ACCESSIBILITY AND DDA IMPACT STATEMENT

Victoria Cross Over Station

Accessibility and DDA impact statement

Applicable to:	Sydney Metro City & Southwest
Author:	Mark Relf, Director, Accessibility Solutions
Owner	Transport for NSW
Status:	Final
Version:	4
Date of issue:	15 May 2018
Review date:	15 May 2018
© Sydney Metro 2018

Figure 8: Denison Street Entrance Level.

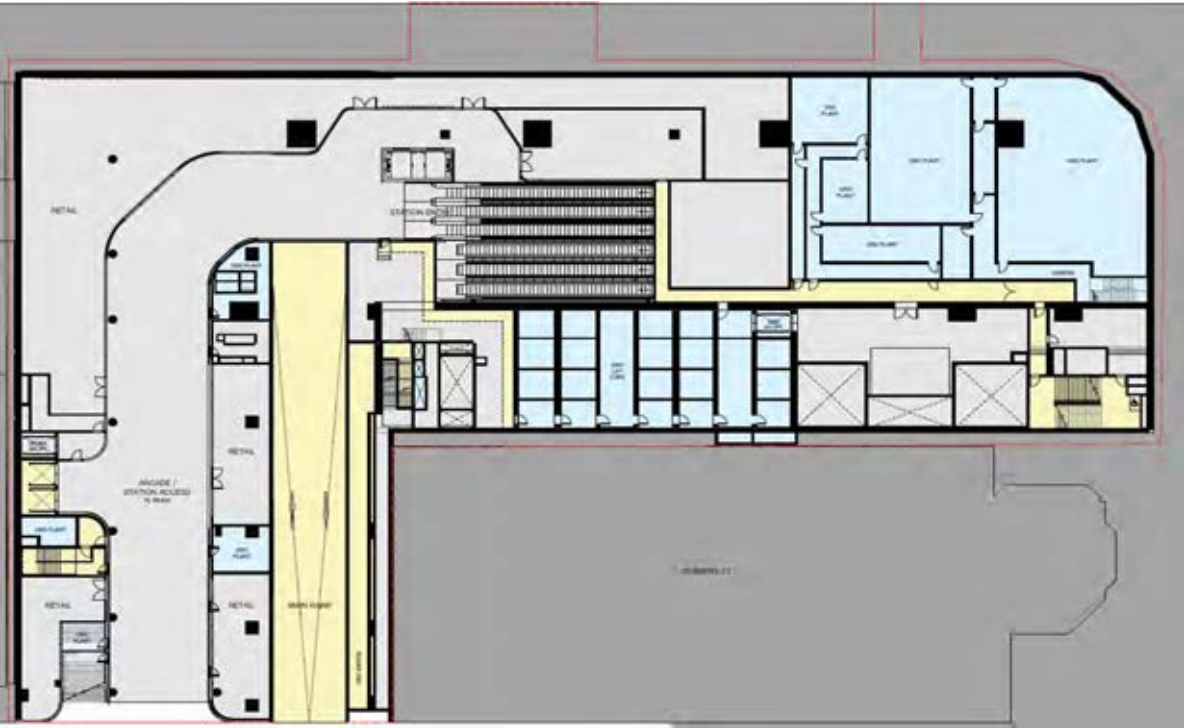
- Denison Street (**Figure 8**) proposes an on-grade arcade style through-site link at the lower ground floor (level 00 on plan) that forms a retail mall and incorporates public access lifts to the basement car park and retail/commercial areas on levels 1 to 3 and on-grade access to two (2) lifts which travel to the station concourse to enable equitable access to all areas to satisfy D3.2 and E3.6 of the BCA and the DDA Access Code.

Figure 10: Basement Level 1

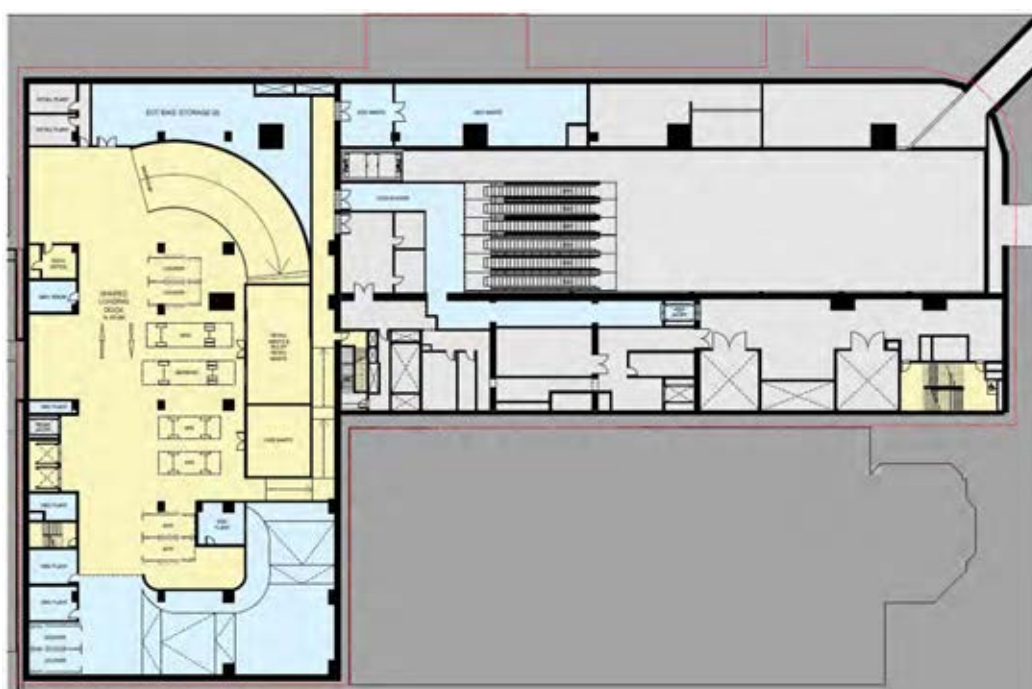
- **Basement Level 1** – Generally, this floor proposes loading dock facilities, end of trip facilities, various plant and equipment and two passenger lifts and two goods lifts servicing this floor which enables equitable access to satisfy D3.3 and E3.5 of the BCA and DDA Access Code (**Figure 10**).

Figure 12: Level 1

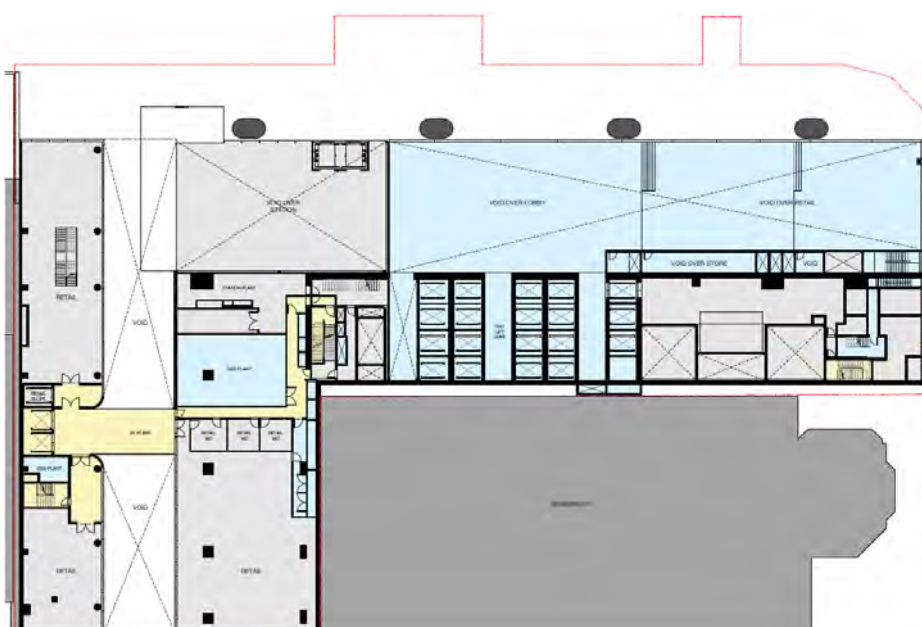
- Level 1** – The plan illustrates a void area over the entry lobby, southern lift lobby and access corridor to retail toilets, which needs to be increased to at least 1600mm (1800mm preferred) to facilitate complying access (**Figure 12**). The plan also shows plant rooms, goods lift access to a delivery/handling area, egress corridors and exit stairways that will comply.

Figure 13: Level 2

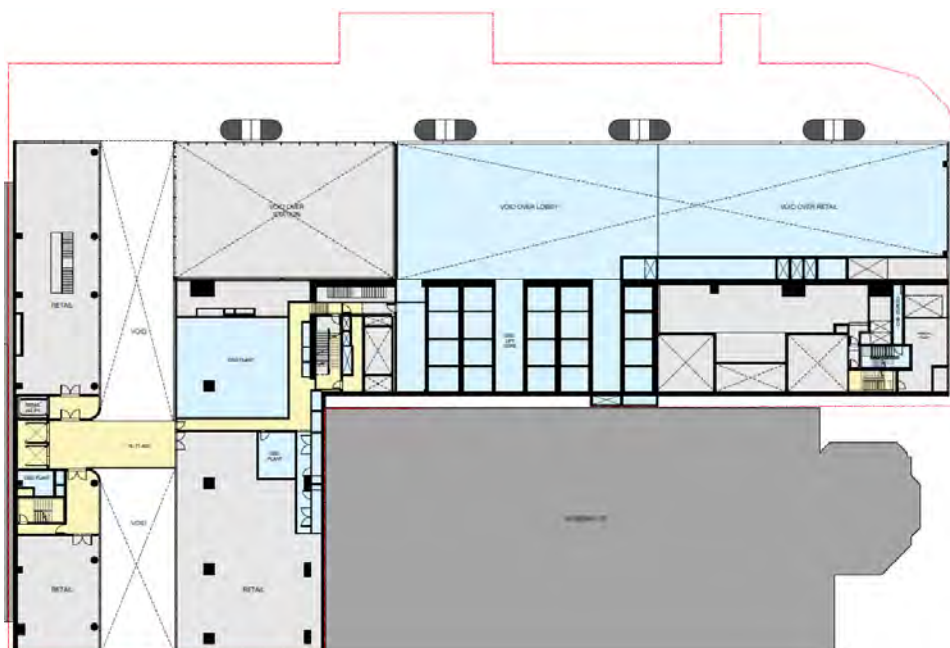
- **Level 2** – The plan illustrates a void area over the entry lobby, southern lift lobby, plant rooms, egress corridors and exit stairways (**Figure 13**).

Figure 14: Level 4

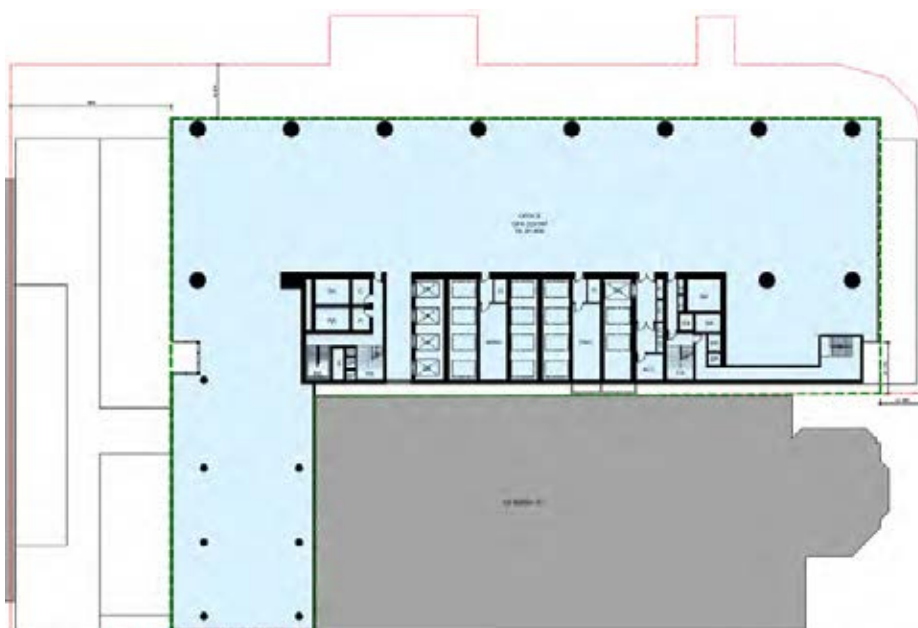
- **Level 3** – The plan illustrates a void area over the entry lobby, plant rooms and egress corridors and stairways.
- **Level 4 Transfer (Levels 5 to 13 similar)** – The plans illustrate lift access to level 4 with an open plan layout across a single level enabling unrestricted access to all areas in accordance with AS1428.1 to satisfy the D3.3 of the BCA and DDA Access Code (**Figure 14**).

- The plans indicate the provision for a unisex wheelchair accessible toilet of at least 2800 X 2500, male and female toilet facilities which can be detailed to comply with AS1428.1 to satisfy F2.4 of the BCA and DDA Access Code.

- Egress provisions include fire isolated stairways and emergency lifts with the latter providing assisted evacuation opportunities for people with disabilities who cannot walk down stairways. The fire isolated stairways can be detailed to comply with D2.17 and D3.3 (a) (iii) of the BCA and DDA Access Code.

Figure 15: Lower mid-rise level

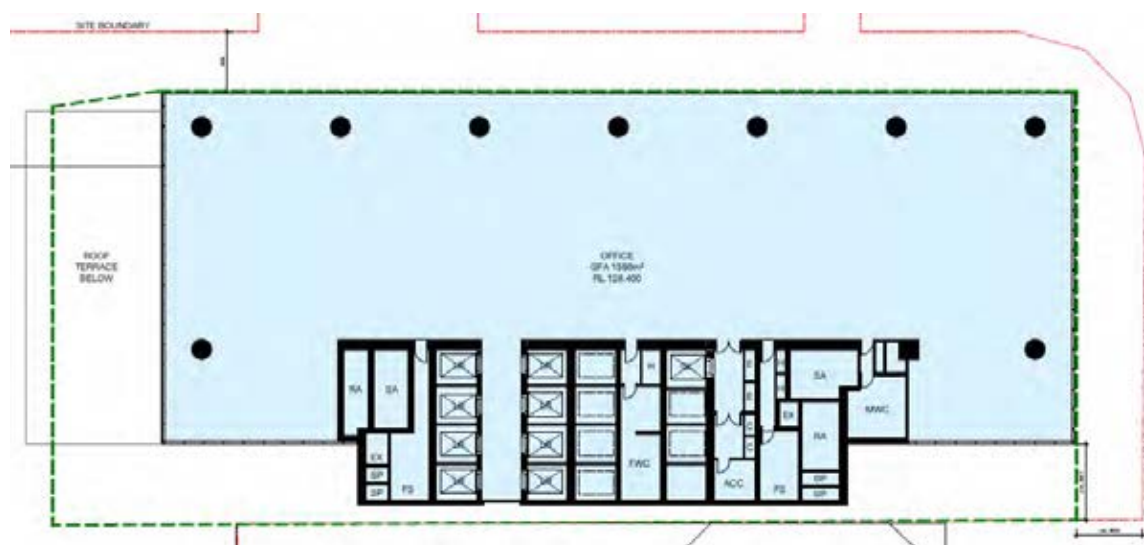
- **Level 14** – The plan shows plant rooms which are not required by D3.3 BCA and DDA Access Code to be accessible.
- **Lower Mid Rise Levels 15 to 22** – The plans illustrate lift access to all mid-rise levels with open plan floors enabling unrestricted access to all areas in accordance with AS1428.1 to satisfy the D3.3 BCA and DDA Access Code (**Figure 15**).

Figure 16: Upper mid-rise level

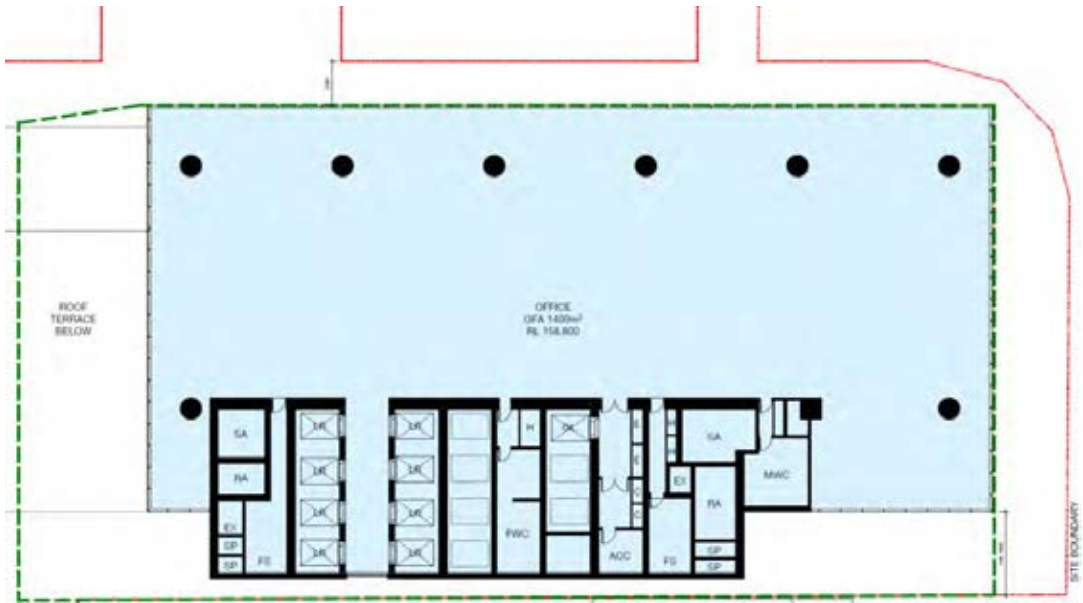
- The plans indicate the provision for a unisex wheelchair accessible toilet of at least 2800 X 2500, male and female toilet facilities which can be detailed to comply with AS1428.1 to satisfy F2.4 of the BCA and DDA Access Code.
- Egress provisions include fire isolated stairways and emergency lifts with the latter providing assisted evacuation opportunities for people with disabilities who cannot walk down stairways. The fire isolated stairways can be detailed to comply with D2.17 and D3.3 (a)(iii) of the BCA and DDA Access Code.
- **Upper Mid Rise Levels 23 to 32** – The plans illustrate lift access to all mid-rise levels with open plan floors across a single floor level enabling unrestricted access to all areas in accordance with AS1428.1 to satisfy the D3.3 BCA and DDA Access Code (**Figure 16**).

Figure 17: High rise level

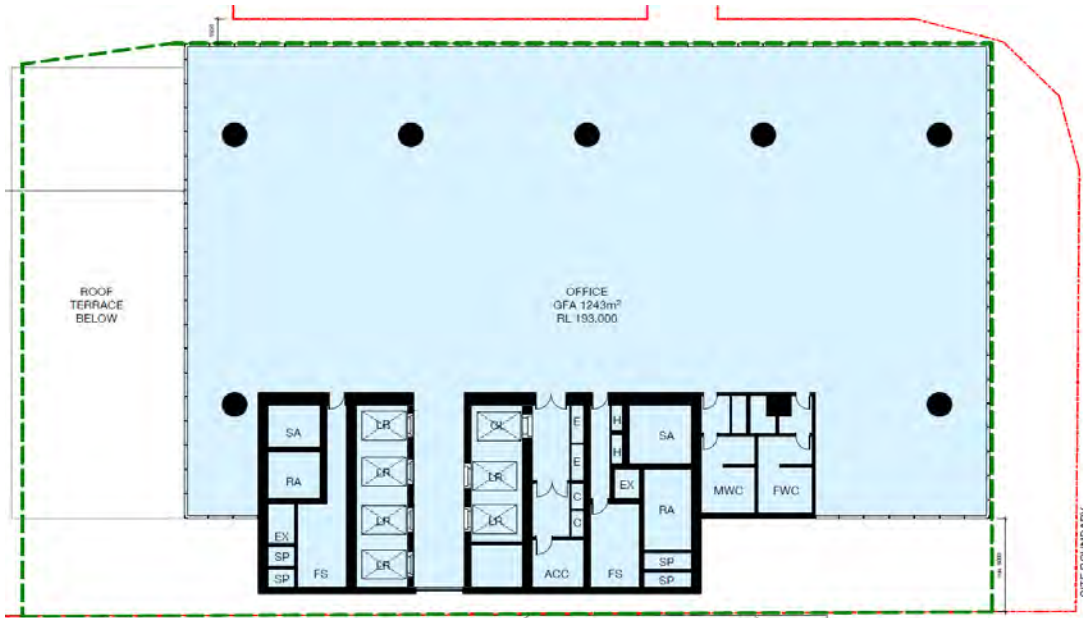
- High Rise Levels 33 to 40** – The plans illustrate lift access to all high rise levels with open plan floors across a single floor level enabling unrestricted access to all areas in accordance with AS1428.1 to satisfy the D3.3 BCA and DDA Access Code (Figure 17).

- The plans indicate the provision for a unisex wheelchair accessible toilet of at least 2800 X 2500, male and female toilet facilities which can be detailed to comply with AS1428.1 to satisfy F2.4 of the BCA and DDA Access Code.

- Egress provisions include fire isolated stairways and emergency lifts with the latter providing assisted evacuation opportunities for people with disabilities who cannot walk down stairways. The fire isolated stairways can be detailed to comply with D2.17 and D3.3 (a)(iii) of the BCA and DDA Access Code.

Figure 19: Example Layout on Level 33

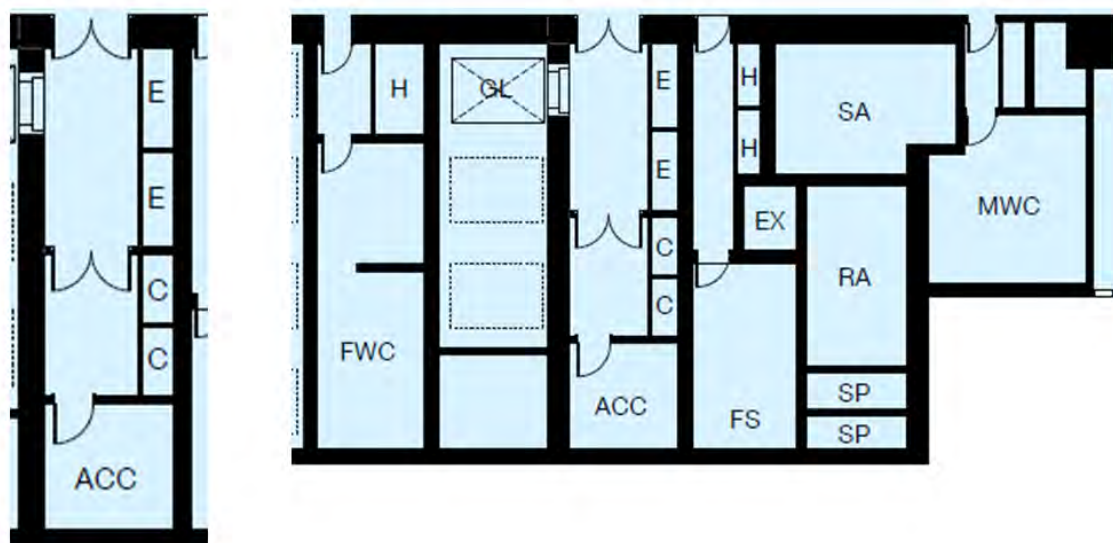
- The development provides a unisex wheelchair accessible toilet on every floor from level 4 to 40 where sanitary facilities are provided and where male and female toilets exist then at least one male and female cubicle shall include ambulant accessible features with AS1428.1 to satisfy and Part F2.4 of the BCA and DDA Access Code (**Figure 19**).
- The end of trip facilities on B2 can also be detailed with a unisex wheelchair accessible toilet / shower facility and ambulant accessible male and female toilets complying with AS1428.1 to satisfy and Part F2.4 of the BCA and DDA Access Code.
